VIRTUAL MEETING OF THE BIRMINGHAM PLANNING BOARD
WEDNESDAY, FEBRUARY 24, 2021
7:30 PM

Re: Special Land Use Permit Amendment and Revised Final Site Plan for Triple Nickel at 555 S. Old Woodward to allow a change of ownership, change of name to Birmingham Pub, and Revised Final Site Plan

On February 3, 2021, the owners of Triple Nickel submitted an application for a Special Land Use Permit Amendment ("SLUP") and Revised Final Site Plan and Design Review ("FSP") for approval to transfer ownership of the existing restaurant operating under an economic development license, to change the name of the restaurant, add new signage and awnings and make minor changes to the interior of the restaurant.

**BUILDING ELEVATIONS
Awnings and Signage**

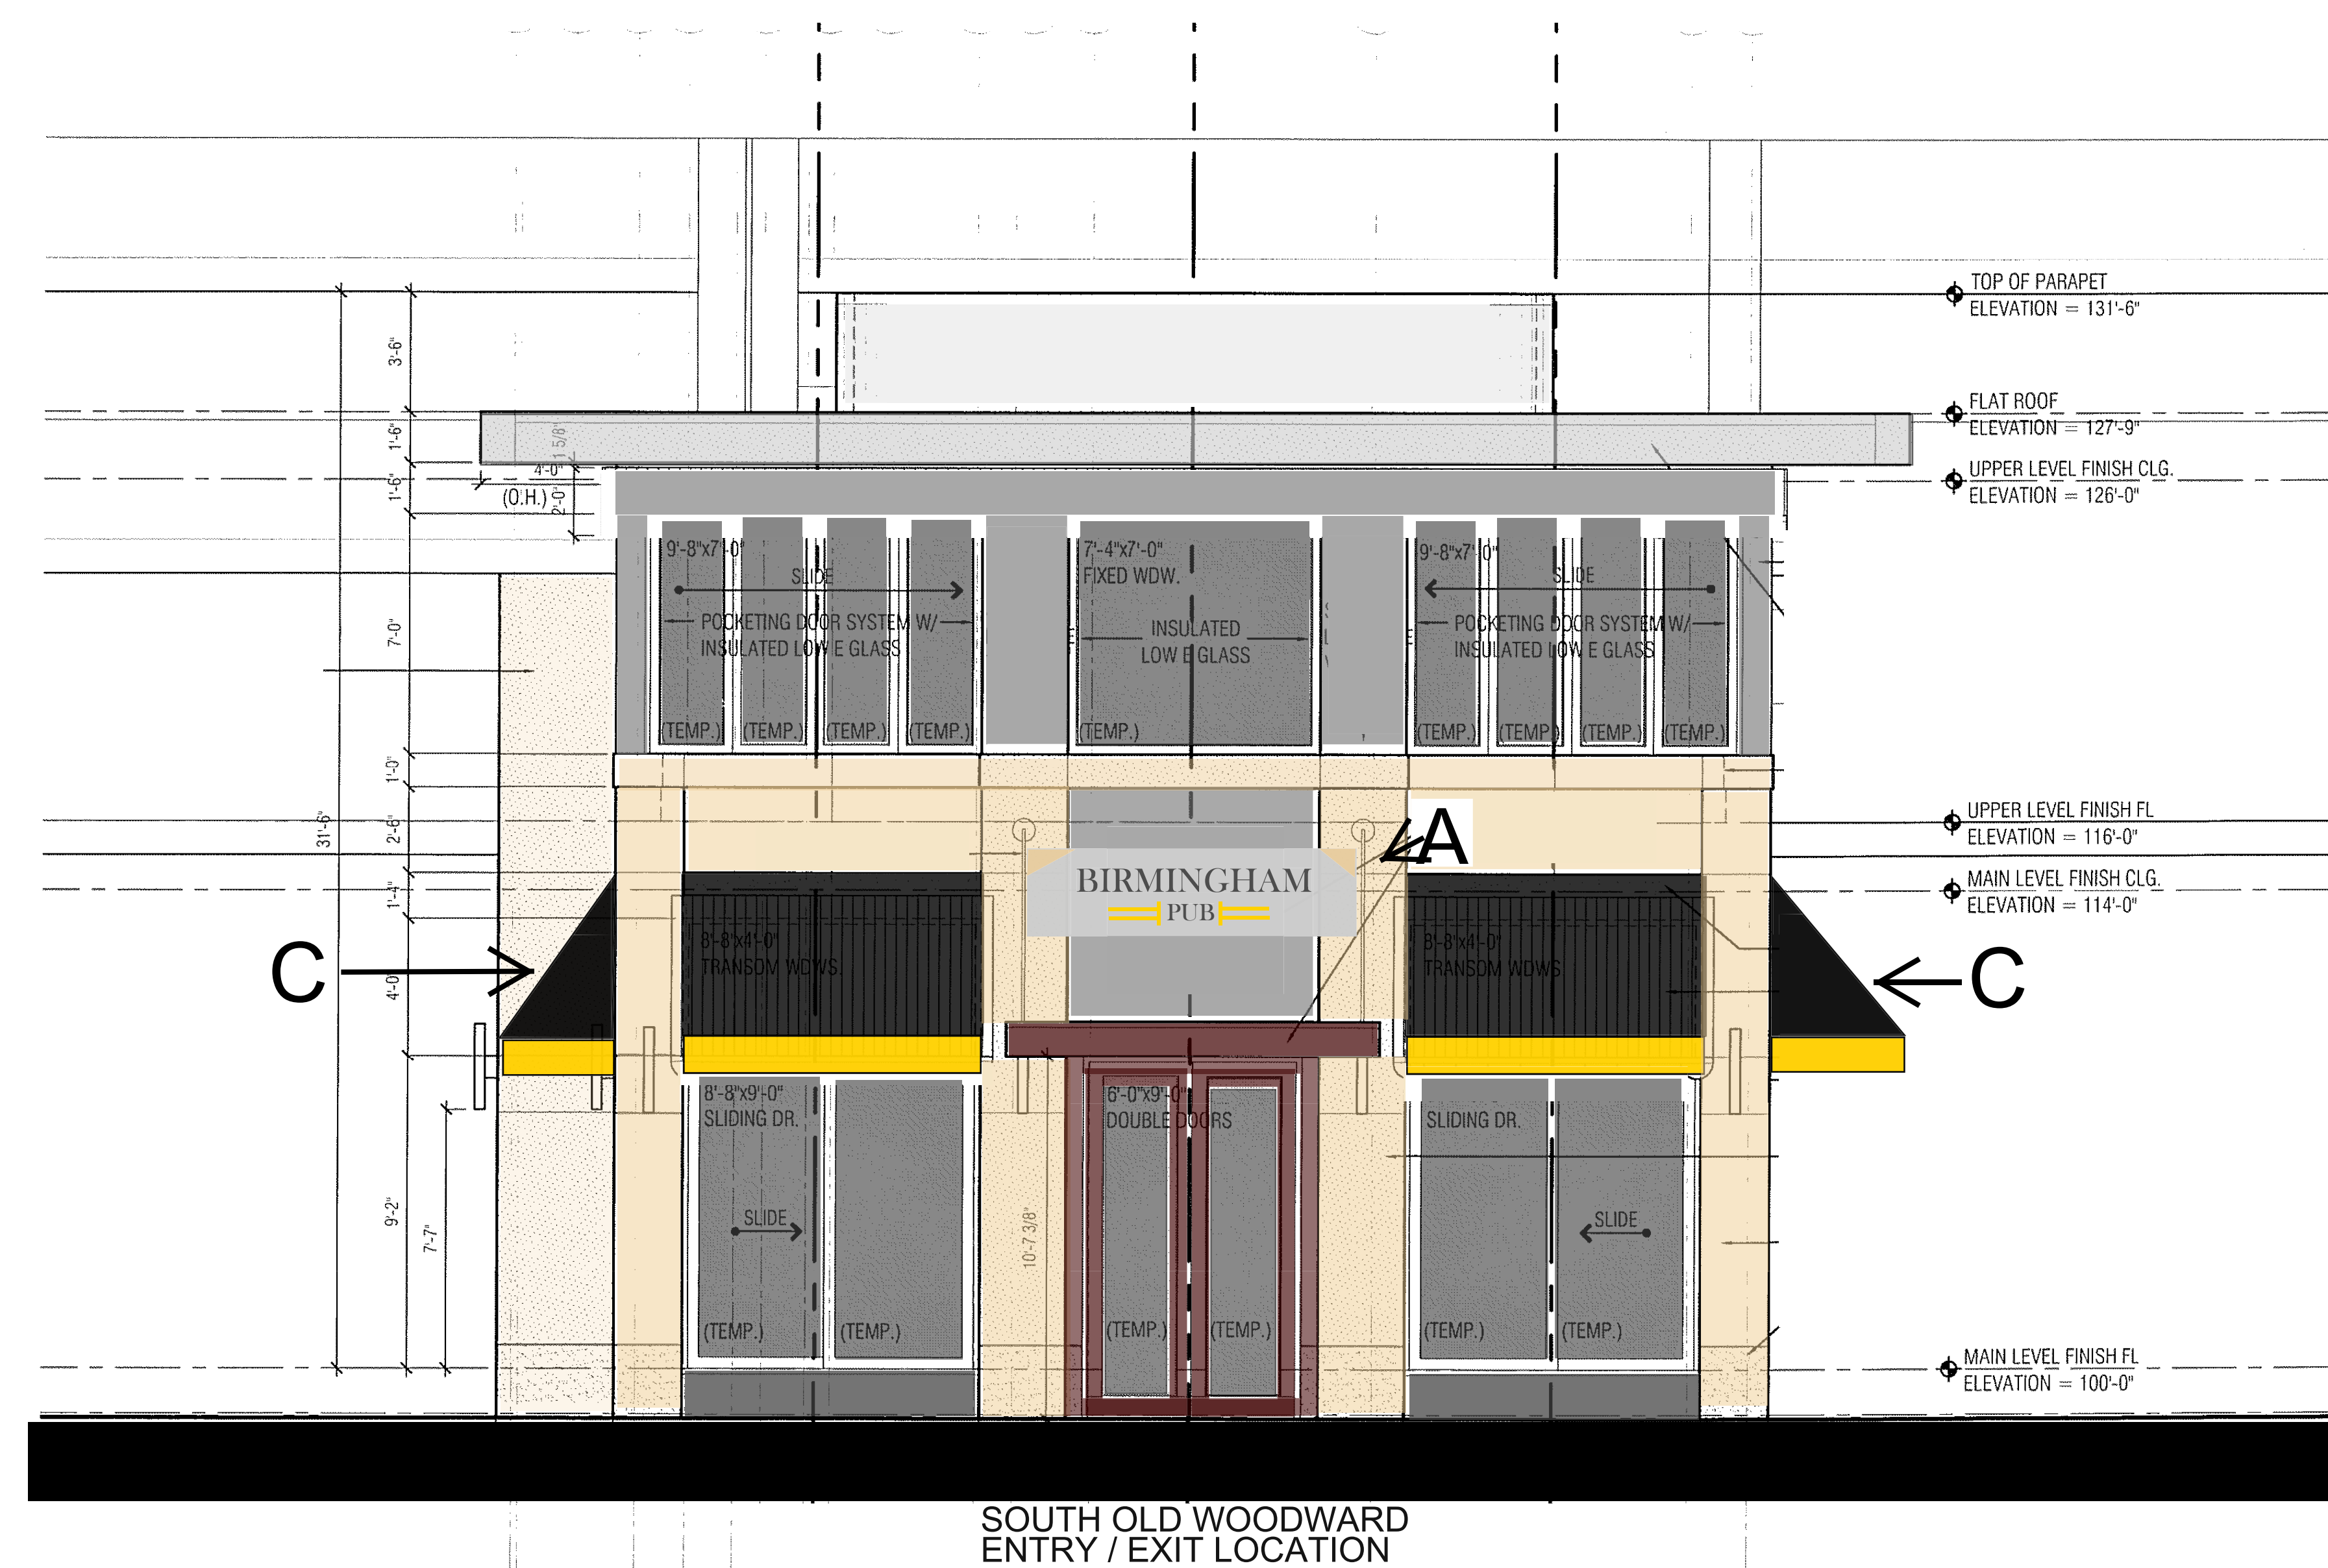
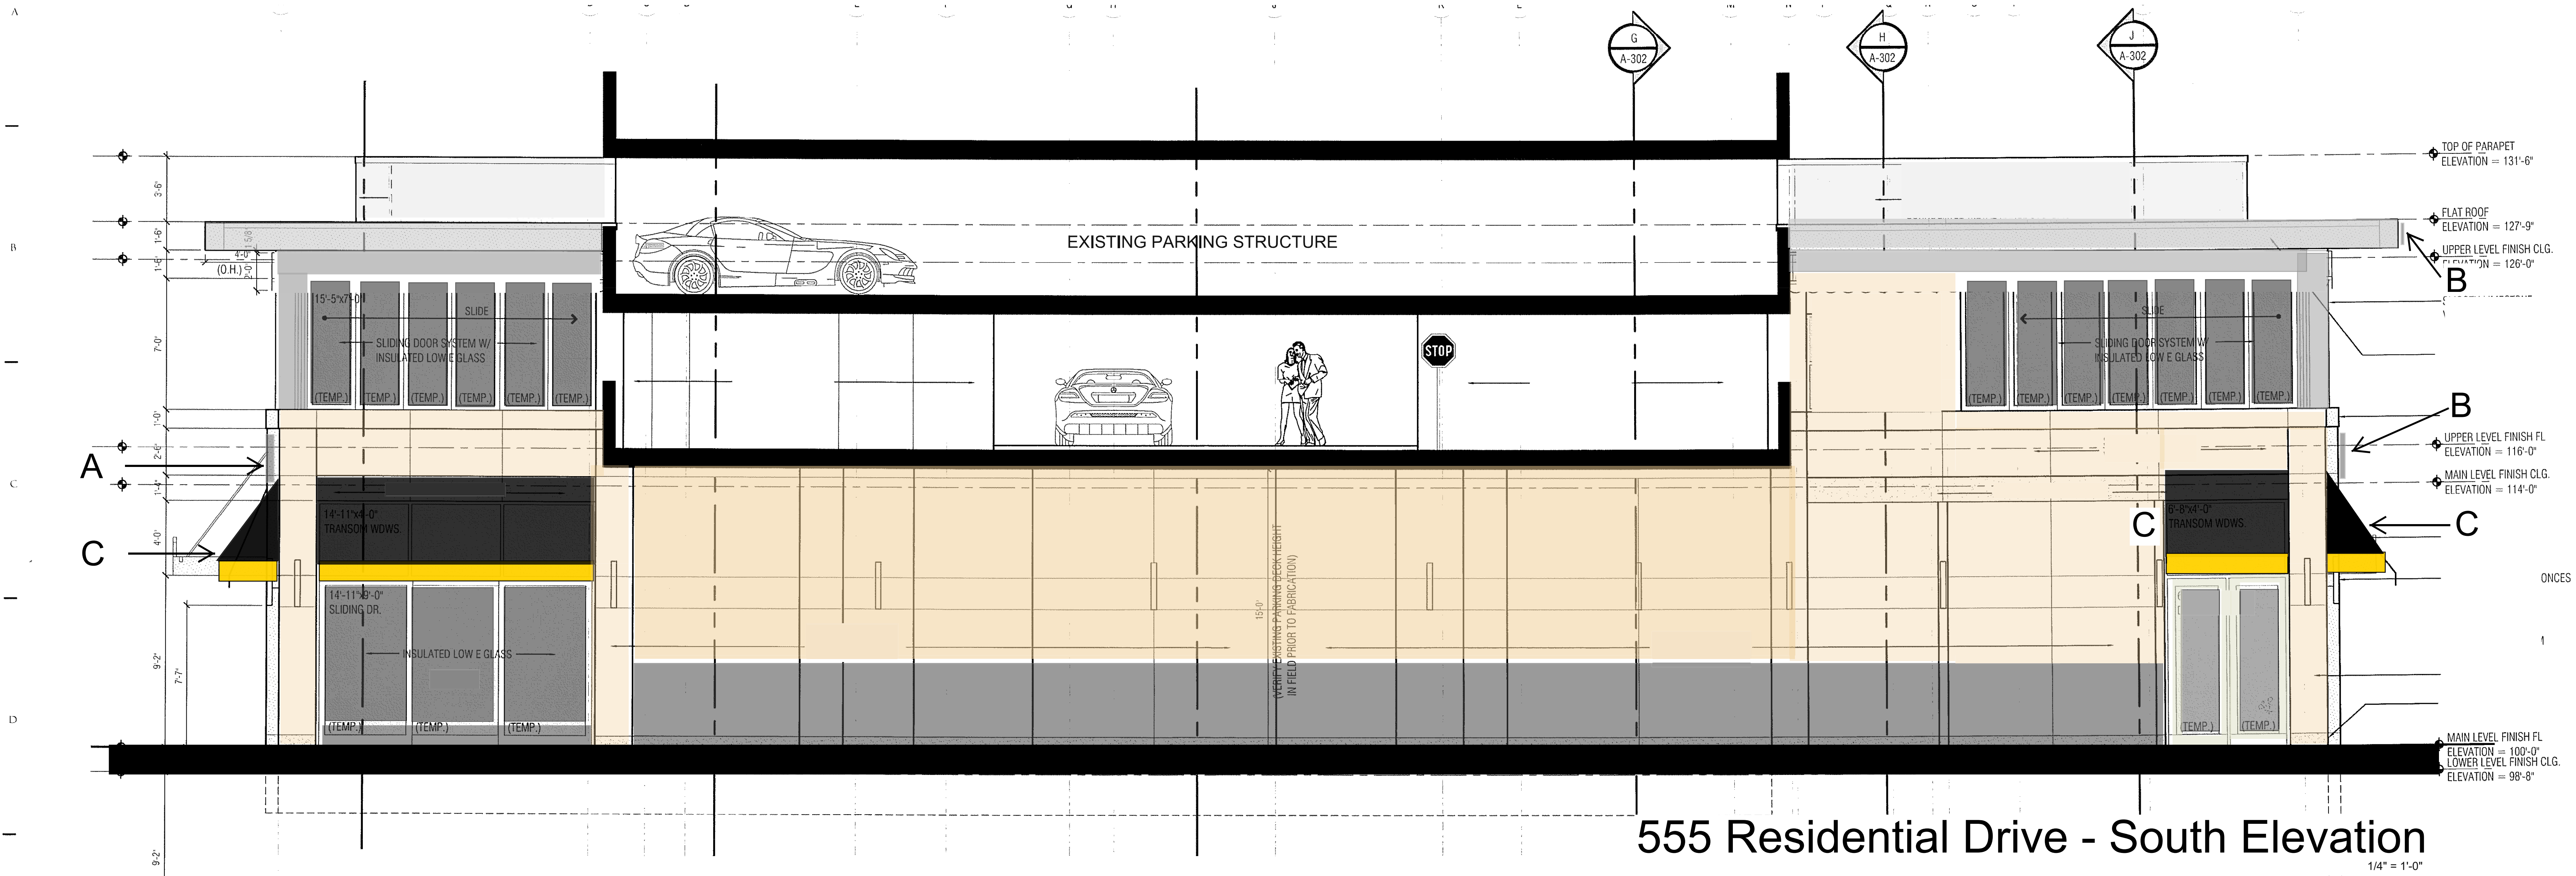
However, the Sign Ordinance also provides that the Planning Board may designate an alternate horizontal building width as the principal building frontage for the purpose of signage. Triple Nickel was previously approved to use the Bowers elevation as the principal building frontage. The Bowers elevation is 110.25' in length, thus permitting a total of 110.25 sq.ft. of total signage on the building, should the Planning Board wish to re-designate the Bowers elevation as the principal building frontage.

If the Planning Board approves the Bowers elevation as the principal building frontage, then the proposed signage is within the total signage limit. If however the Planning Board does not feel that it is appropriate to designate Bowers as the principal building frontage, then the applicant will be required to reduce the overall building signage by 47.76 sq.ft.

In accordance with section 1.05(K)(2) of the Sign Ordinance, building identification signage is permitted above the first floor sign band if non-illuminated. However, the proposed building identification signage on Woodward Avenue is proposed to be illuminated with internally lit led (blue) and halo lit (white) channel letters. **Illumination of such signage is not permitted. The applicant will be required to remove the proposed illumination or obtain a variance from the Board of Zoning Appeals.**

Finally, as noted in the chart above, the applicant is required to provide material, color and lighting details for all signage.

- (1) The Planning Board designates the Bowers elevation as the principal building frontage or the applicant reduces the overall building signage by 47.76 sq. ft.;
- (2) The applicant remove the proposed illumination from the building identification sign on Woodward Avenue or obtain a variance from the Board of Zoning Appeals;
- (3) Applicant provide all material, color and lighting specifications for all signage; and
- (4) Applicant execute a revised contract with the City of Birmingham outlining the nature of the proposed operation of Birmingham Pub and approving the use of the existing Economic Development liquor license under the new name Birmingham Pub.
